PRELIMINARY OVERALL AREA DEVELOPMENT PLAN
FOR
WOODSTONE VILLAS SUBDIVISION

PRELIMINARY OVERALL AREA DEVELOPMENT PLAN APPLICATION (POADP)

Re: Woodstone Villas

POADP # 551

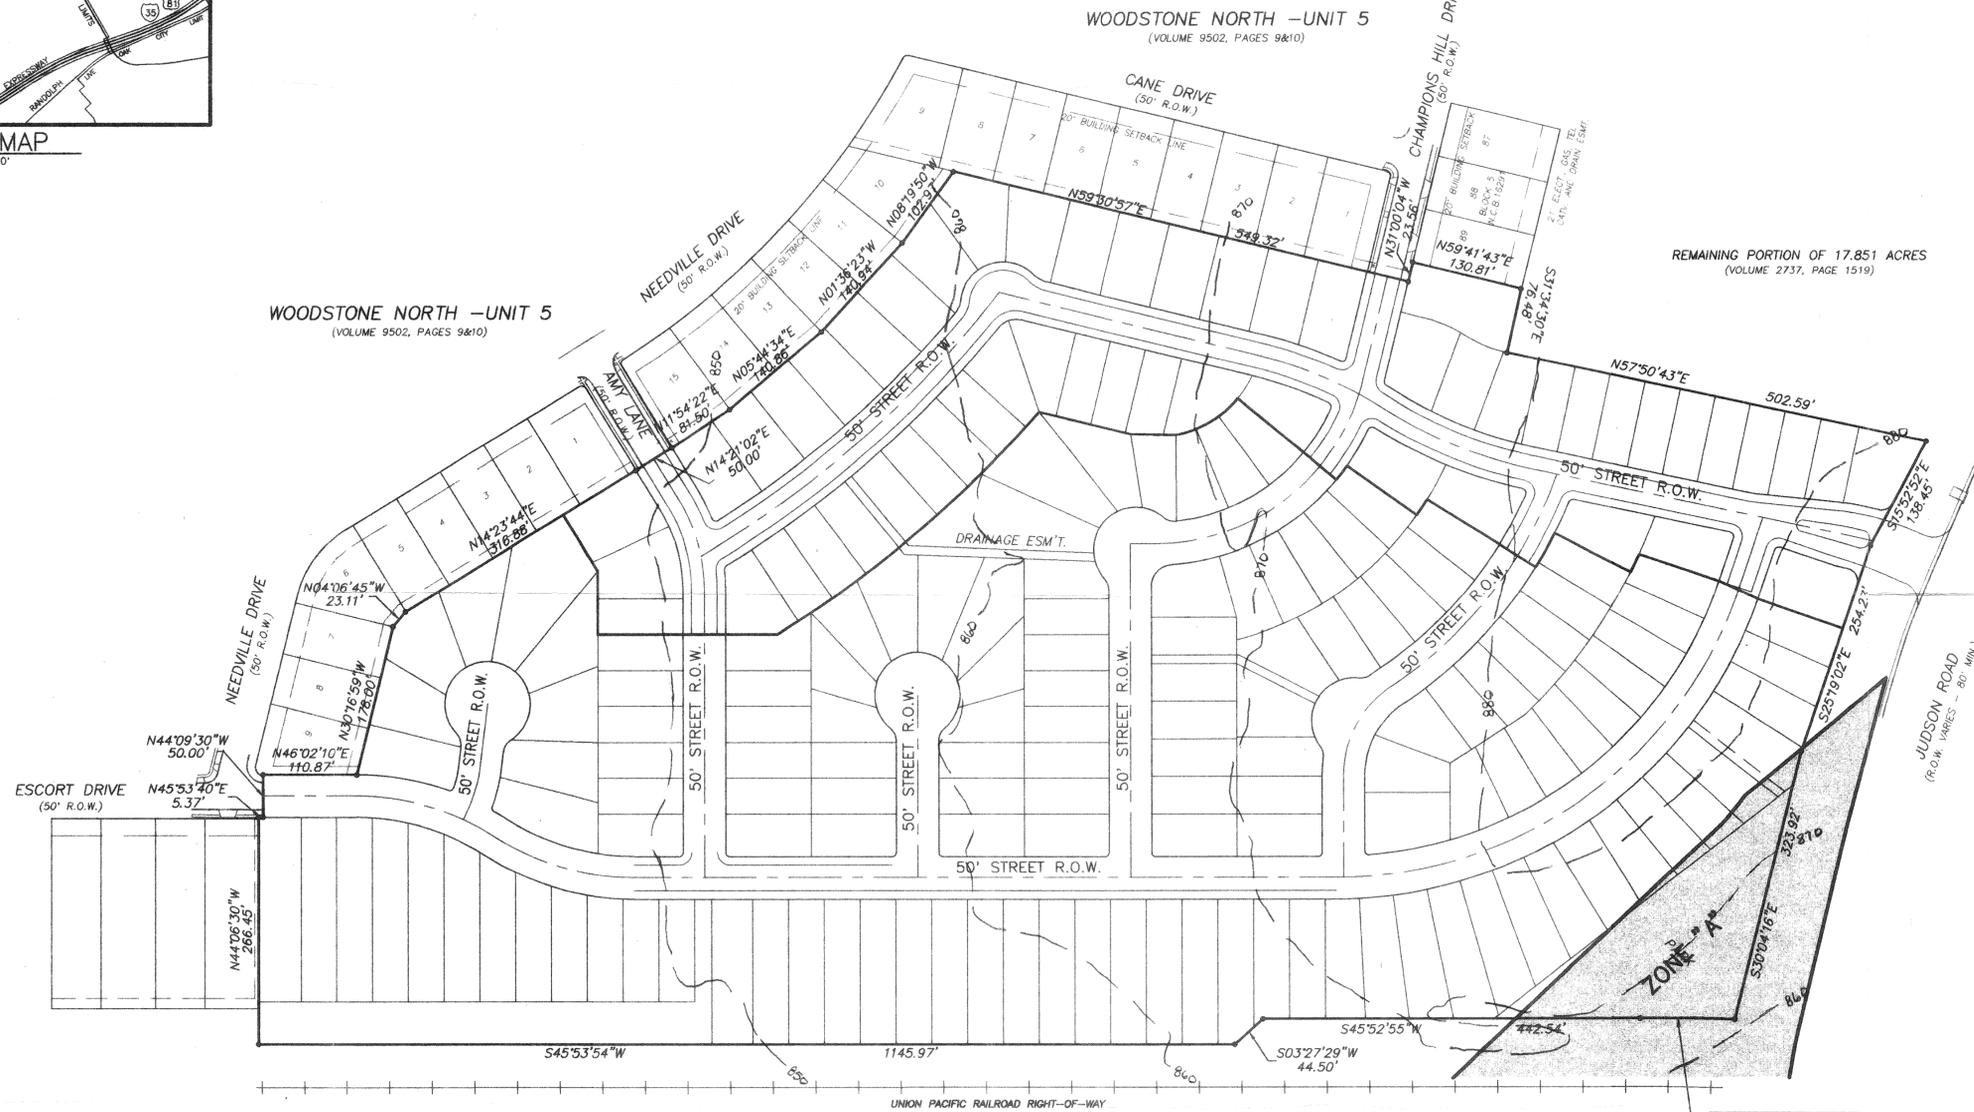
- Based on the topography, a Flood Plain Study and drainage review will probably be required during the platting process. In addition, a detention basins for drainage to the railroad tracts may be required.
- Judson Road is a Secondary Type A Major Thoroughfare, and will require a total of 86' of ROW.
